Preliminary Consultation
MONTGOMERY COUNTY HISTORIC PRESERVATION COMMISSION
STAFF REPORT

Address:	15 Columbia Ave., Takoma Park	Meeting Date:	6/9/2021
Resource:	Non-Contributing Resource Takoma Park Historic District	Report Date:	6/2/2021
Applicant:	Wakako Tokunga	Public Notice:	5/26/2021
Review:	Preliminary Consultation	Staff:	Dan Bruechert
Proposal:	Building Alterations, Rear Addition, Hardscape Alteration, and Accessory Structure Construction

1 WEST ELEVATION
A200 1/4" = 1'-0"

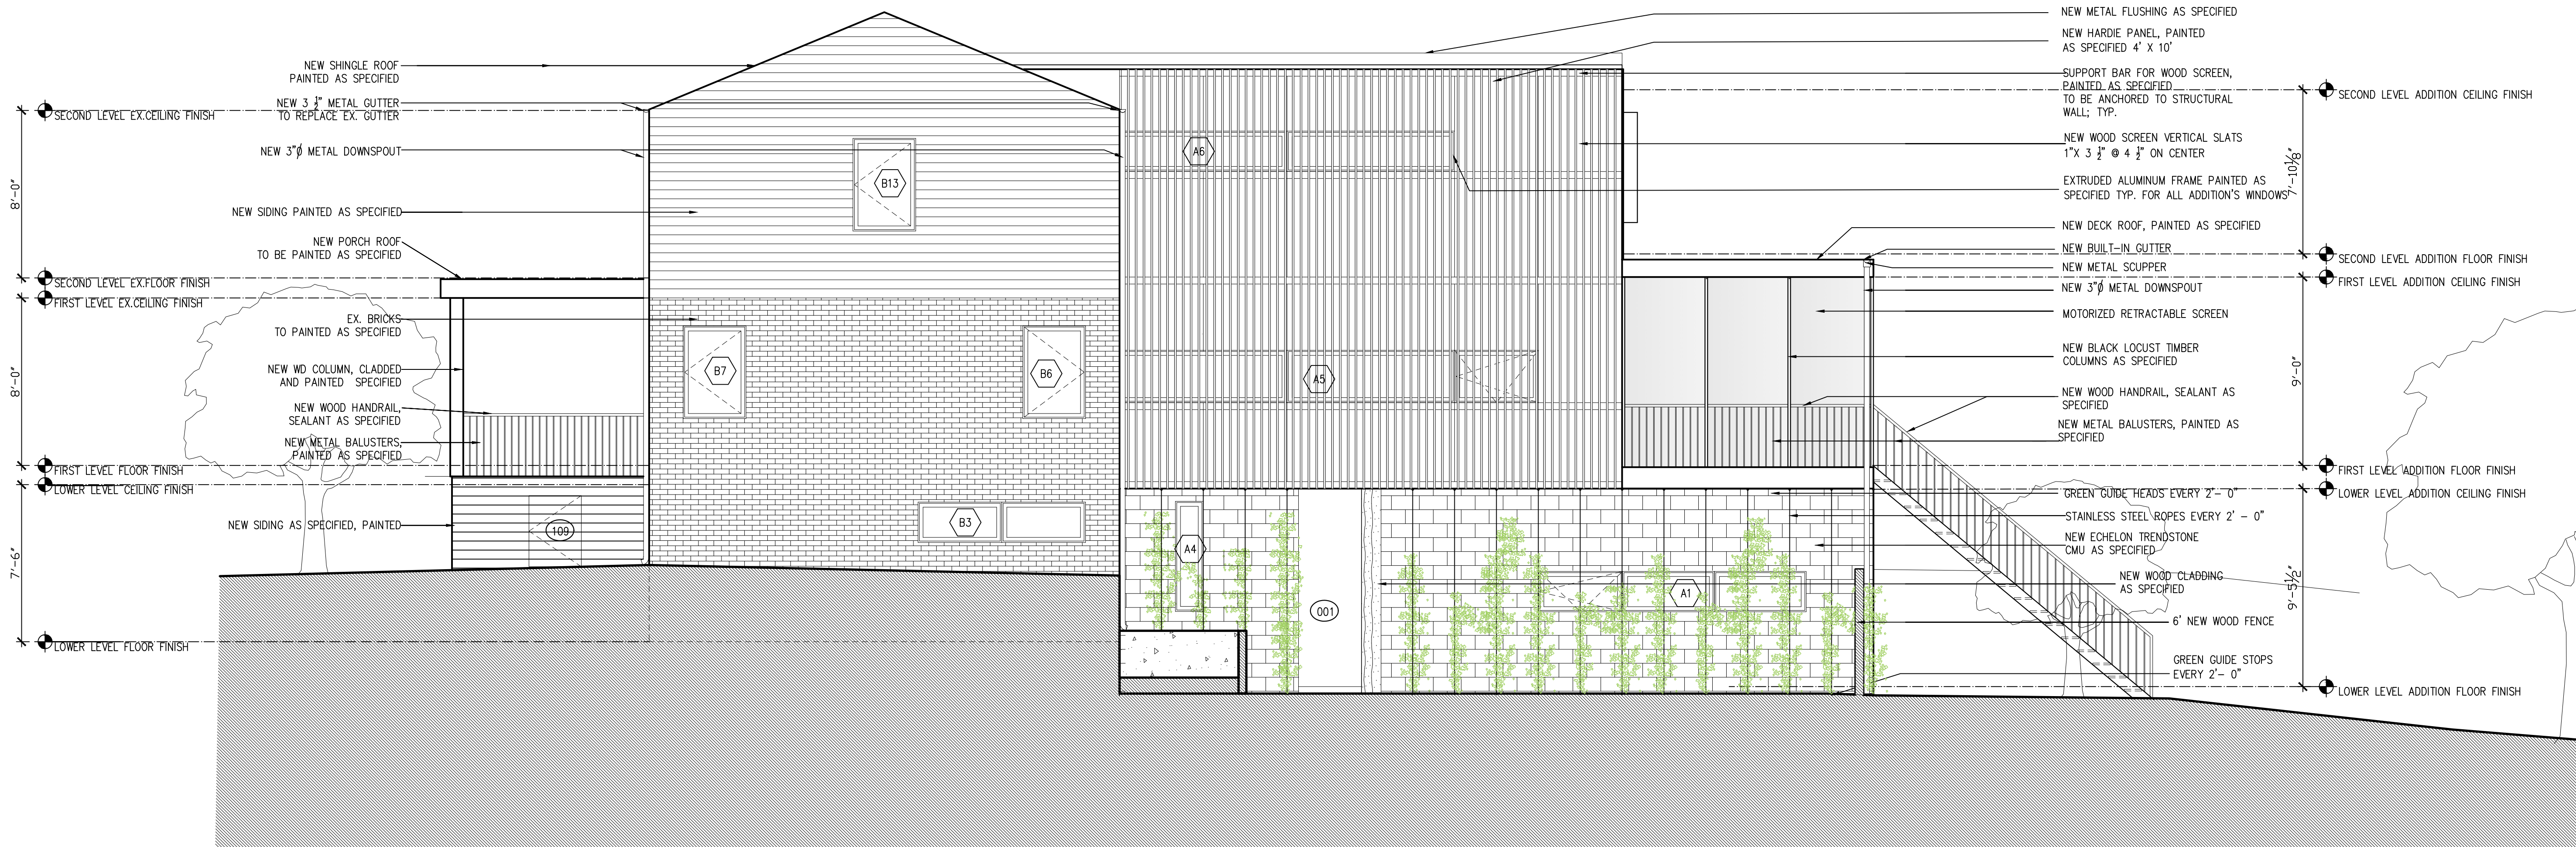
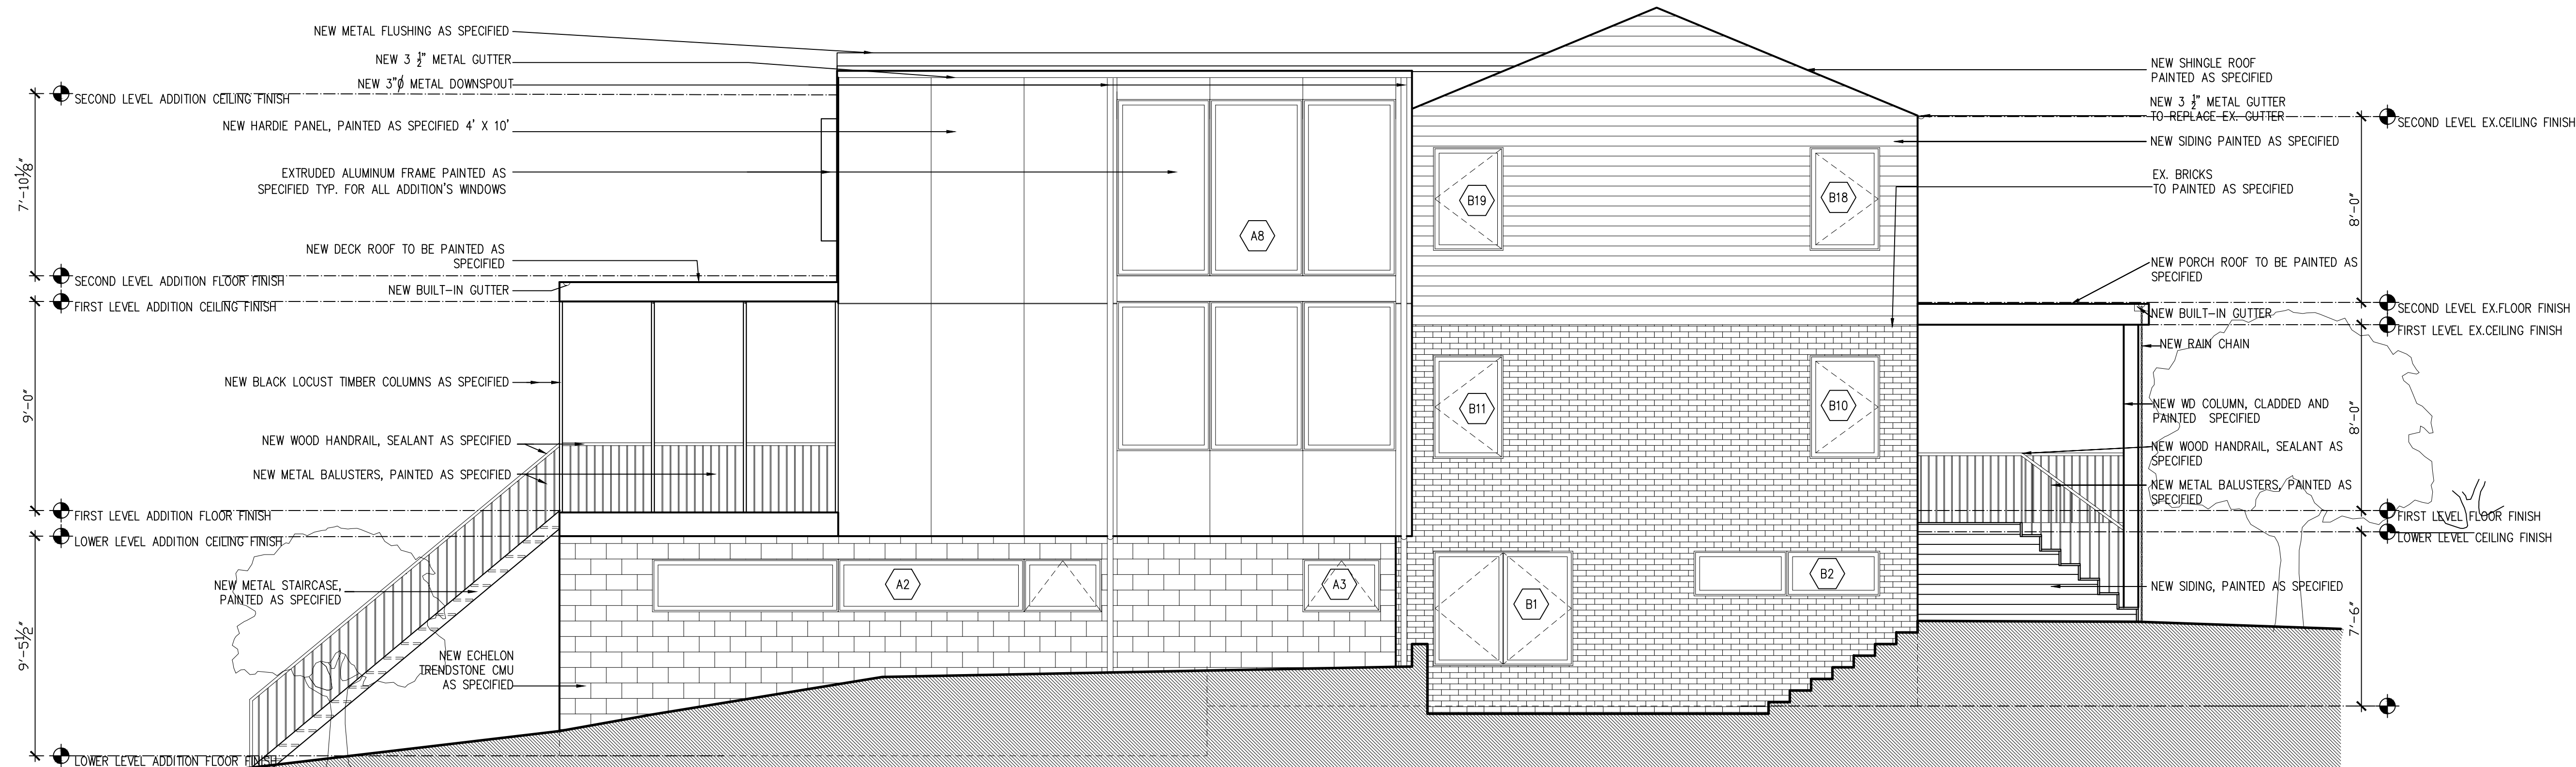
The applicant proposes to remove the existing windows and doors, and install new windows and doors in a new configuration. The asbestos siding on the second floor will be removed and replaced with fiber cement clapboard siding. The proposed replacement windows are Marvin Ultimate, aluminum-clad wood windows, installed as single-lite casement and fixed windows in new locations. The existing front door will be removed, relocated to the left side of the front elevation, and replaced with a new wood door and sidelight.

On the right side elevation, the applicant proposes to remove the existing chimney. Both side-gable elevations will have their existing windows removed and replaced. The replacement windows will be Marvin Ultimate to match the front of the house. New window openings will be larger than the existing windows.

Staff finds that all of these changes are consistent with the *Design Guidelines*, as they will not change the size or massing of the existing Non-Contributing Resource. Based on a lenient review, Staff would recommend the HPC approve these changes as a HAWP.
